SUBJECT: DA2021/1522 - 189 Riverview Road, Avalon Beach

I addressed the NBLPP on 2 February 2022 regarding this development and I remain very concerned about the material inconsistencies and errors in the plans, the height and breadth of the windows facing my property, the extent of overlooking and the proposed Vergola. My specific comments relating to these concerns are listed below;

Figure 1: Overlooking windows

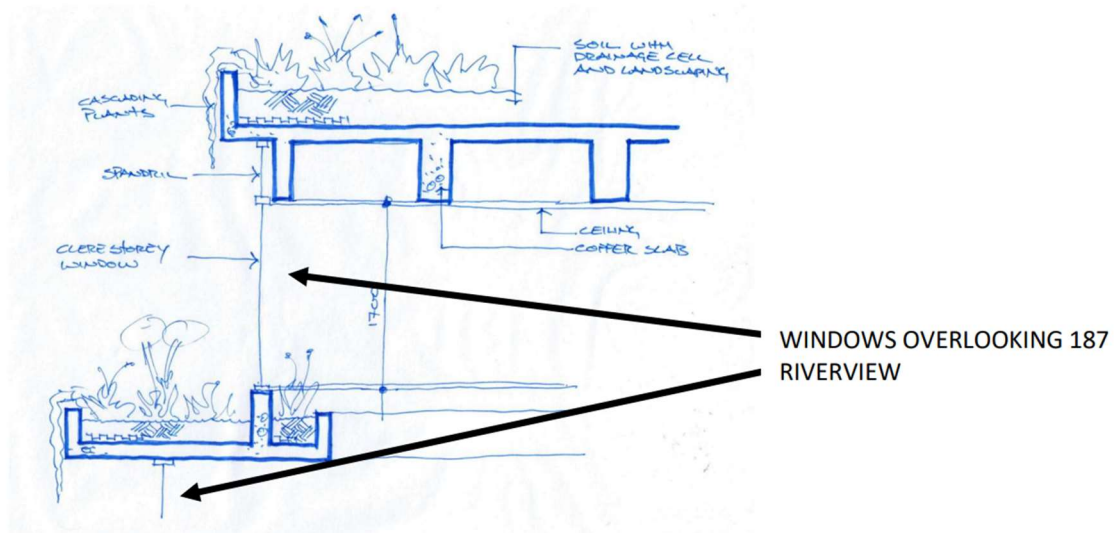
- a) Plans state “high level windows” but the renderings and drawings submitted show full height windows from floor level to ceiling (refer to the images attached in Figure’s 1-4 below). Given the cascading nature of the house, full height and full length windows all along the southern façade creates significant overlooking from higher levels inside the proposed house down into my house. There is limited or non-compliant screening proposed on the plans - the DCP requires screens with 25% transparency or windows with obscured glass. Practically the entire southern façade is proposed to be transparent glass and if a future development was to be undertaken on my property, the DCP would not allow me to have any windows on my northern side because they must be off-set from those in the adjacent building.

- A. **Sill heights of the windows that face south, in particular the windows in the “DOUBLE VOLUME” space and the “Music Room” & “Lounge Room” area to have a sill height no lower than RL28.3. Other windows along the southern elevation to have a sill height of 1.7m above the floor level. Privacy screens to have maximum 25% openings per the DCP.**

Figure 2: Overlooking roof-top terrace

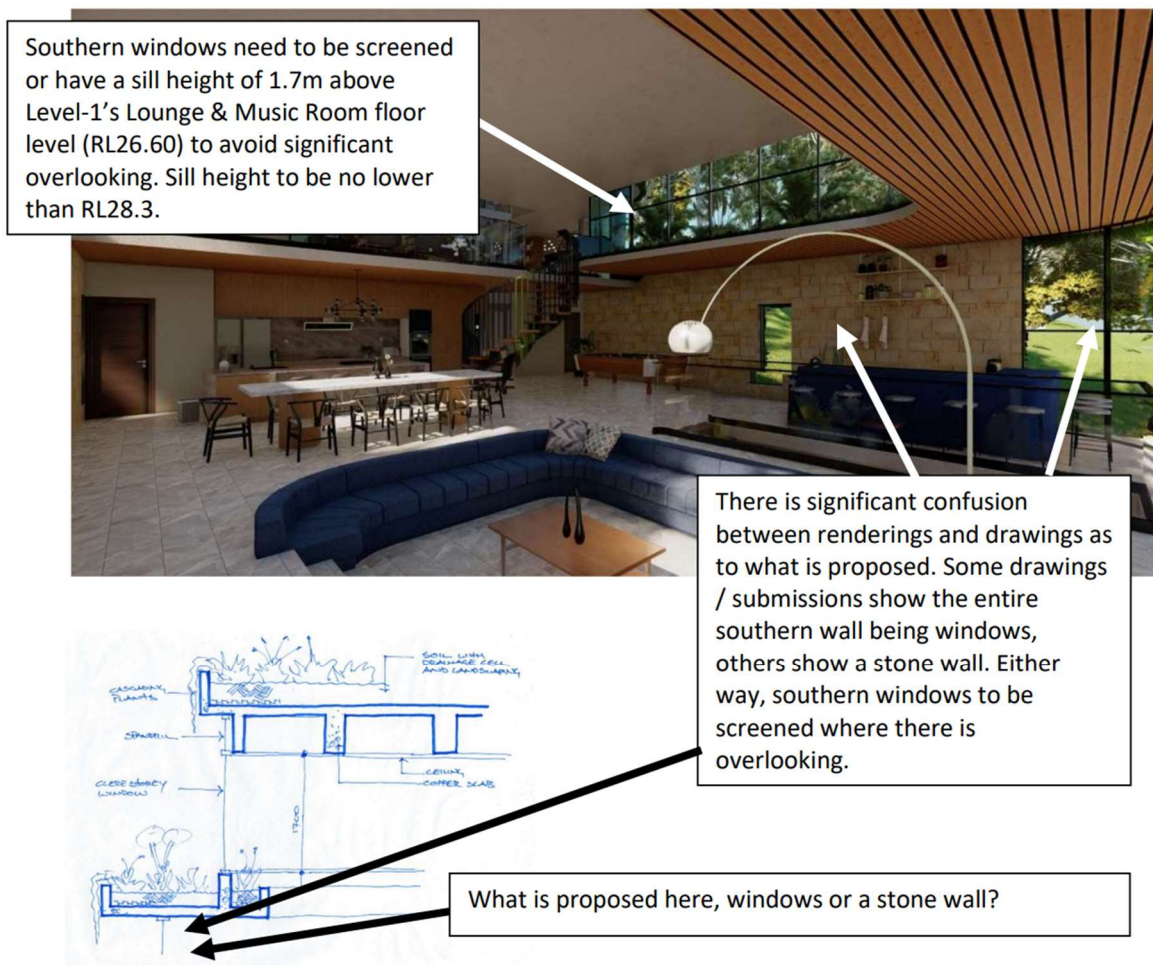
- c) A large rooftop terrace (which can be seen on drawings 001-200 (page 7), 001-311 (page 46), 001-270 (page 39), etc.) is proposed without any screening, further creating significant overlooking onto my main deck and property. Rooftop terraces are not permitted under the DCP. The proposed balustrading already exceeds the 8.5m height plane and 45-degree envelope so screening would result in further non-compliances.

- B. **The trafficable rooftop deck at RL29.90 be deleted along with the associated balustrade.** (The proposed balustrading already exceeds the 8.5m height plane and 45 degree envelope, therefore adding privacy screens would result in a greater non-compliance).

Figure 3: Overlooking & inconsistent design drawings / imagery

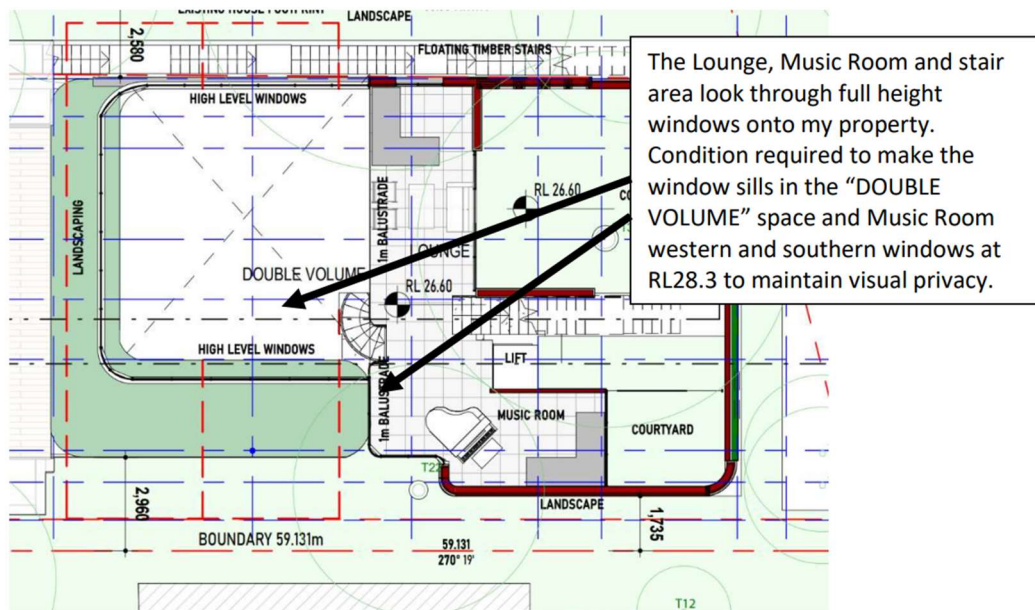
Action #3 from the first NBLPP meeting required a new Northern Elevation be produced but as referenced in my above comments, the Southern Elevation is also inconsistent with other drawings and imagery (refer to an example given in Figure 3 above). The windows and the Vergola are inconsistently represented in many of the drawings / sections. The 45-degree envelope drawing is incorrect and needs to be re-drawn including the Vergola. The shadow diagrams appear incorrect and need to be re-issued. It's unclear what is to be approved. There are a lot of plants drawn on the plans which obscure the actual structure – eg: the West Elevation drawing 001-302 (page 43) is showing so many trees that it's impossible to see what structure is proposed.

The applicant to submit one set of plans, which show consistent levels, window designs, screening, etc., with the actual built structure clearly identified and not obscured by images of plants.

Figure: 5: Vergola drawn at different levels and incorrect envelope drawing.

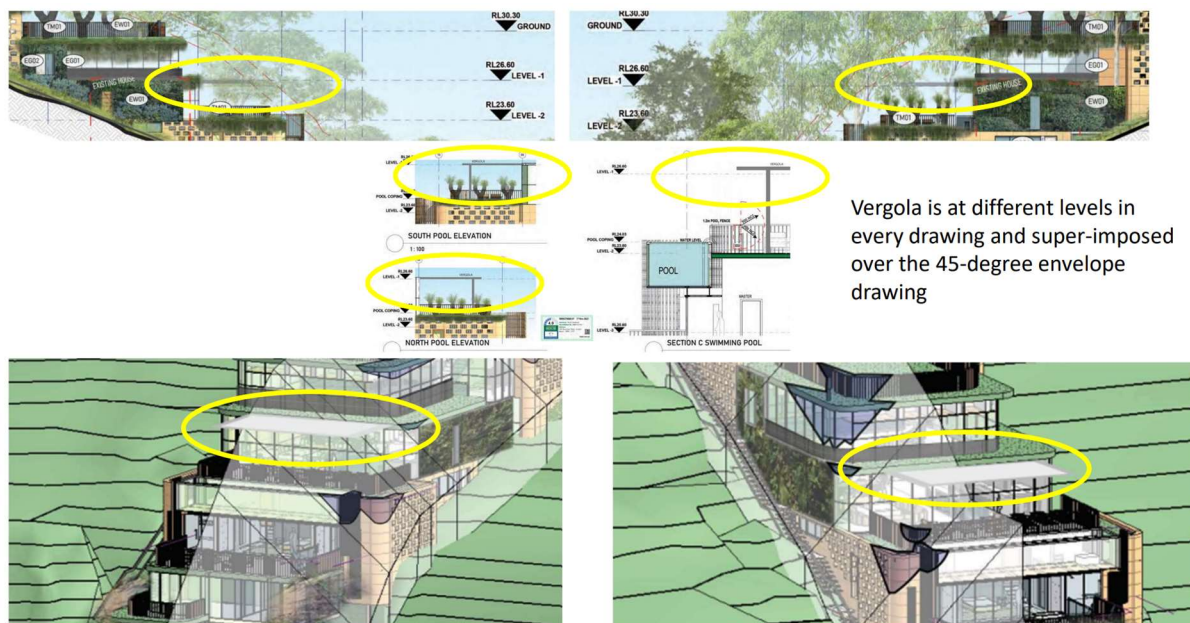
- a) Drawing 001-050 (page 2) shows no Vergola.
 - b) Drawing 001-101 (page 4) shows it as less than the width of the pool, drawing 001-211 (page 15) shows it as greater than the width of the pool.

- c) Drawing 001-270 (page 39) shows it as in line with the top of the roof on the southern drawing but below ceiling level on the northern drawing.
 - d) Drawing 001-270 (page 39) is incorrect because it is not showing the Vergola as being well outside of the 45 degree envelope in the same manner as the other envelope exceedances are outlined.

- e) Drawing 001-251 (page 20) doesn't show the Vergola as outside the 8.5m height limit but the Northern Elevation drawing 001-300 (page 41) does show it above 8.5m (it's not integrated into the CAD program).

- f) On drawing 001-300 (page 41) the top of the Vergola is drawn lower than RL26.60 but on drawing 001-301 (page 42) it's above RL26.60.
- g) Drawing 001-211 (page 15) shows several different levels on the one page.
I don't know where it is proposed to be built but it is clearly well outside of the 45 degree envelope, significantly impacts views and is non-compliant.

The Vergola as shown on the "East Pool Elevation" drawing is as thick as the roof structure. Vergola framework must be a minimum of 250mm thick and it is likely to be engineered more heavily given the very high wind loadings in this location. The heavily framed Vergola is well outside of the building envelope, is non-compliant and has a material impact on our views.

Requested Council condition relating to the Vergola
Removal of the Vergola
